(10) International Publication Number  
**WO 2007/012181 A1**

(54) Title: APPARATUS AND METHOD FOR TREATING FGD BLOWDOWN OR SIMILAR LIQUIDS

## INTERNATIONAL SEARCH REPORT

FIG. 2

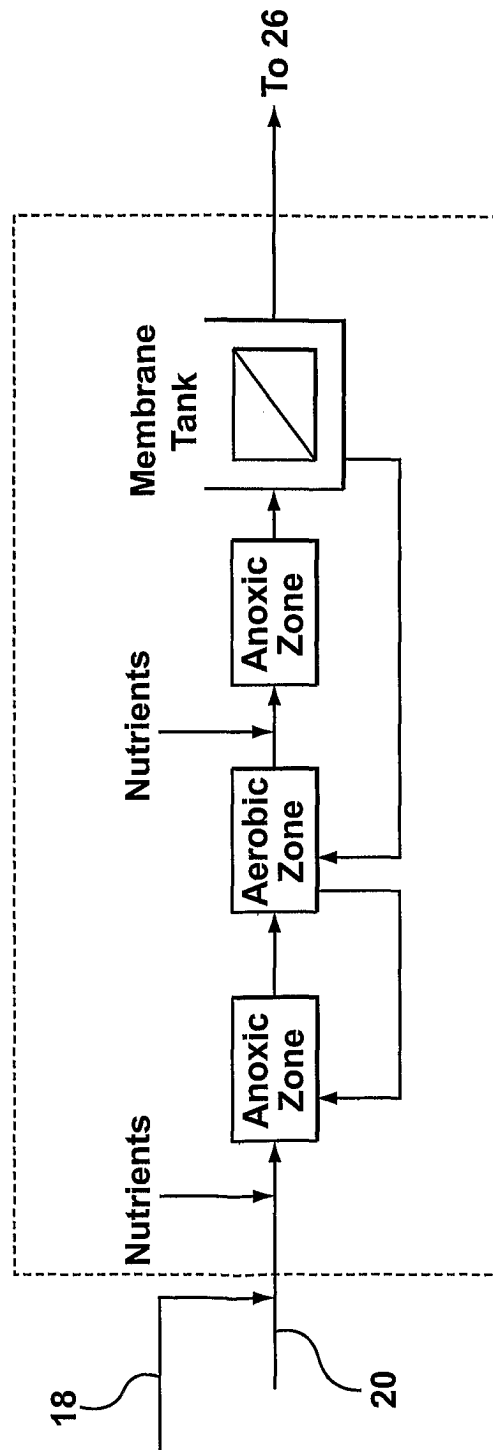
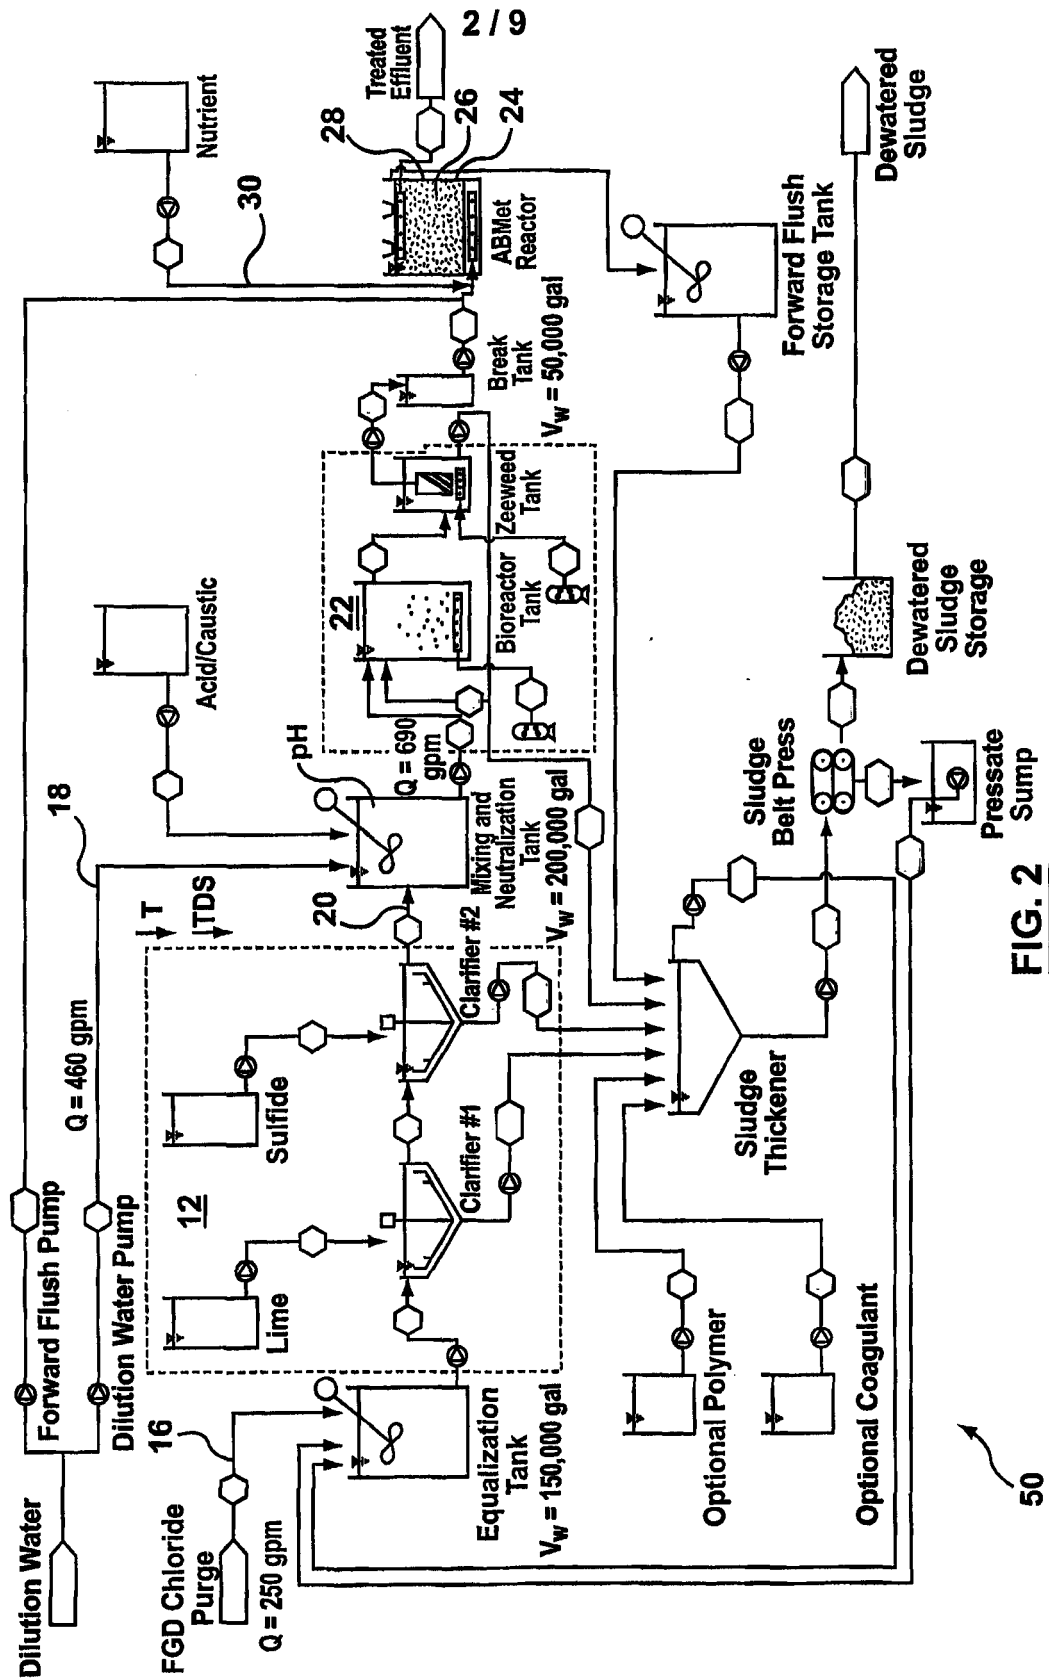
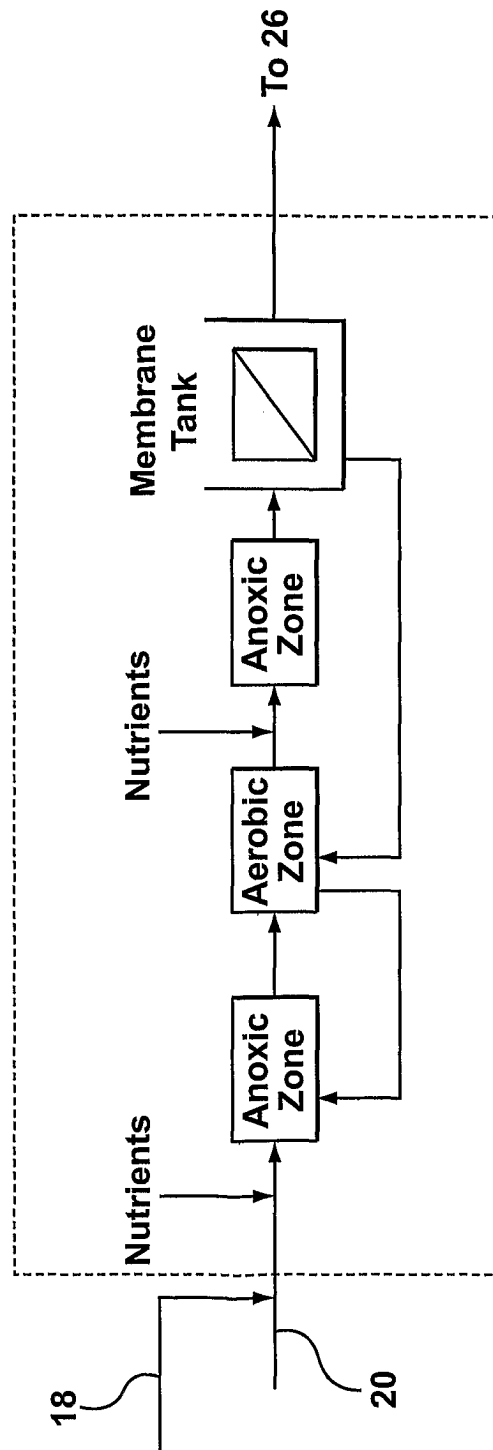
The drawings do not comply with section 82 of the *Patent Rules*. Reference characters not mentioned in the description should not appear in the drawings, and vice versa. Figure 2 contains reference numerals 1, 2, 3, 4, 6, 7, 8, 9, 10, 13, 15, 17, 19, 21 which are not mentioned in the description. Also, figure 9 contains reference numeral 222 which is not mentioned in the description.

Please replace Figure 2 with new Figure 2 submitted herewith.

Figure 2 has been amended to remove the reference numerals noted in the Requisition.
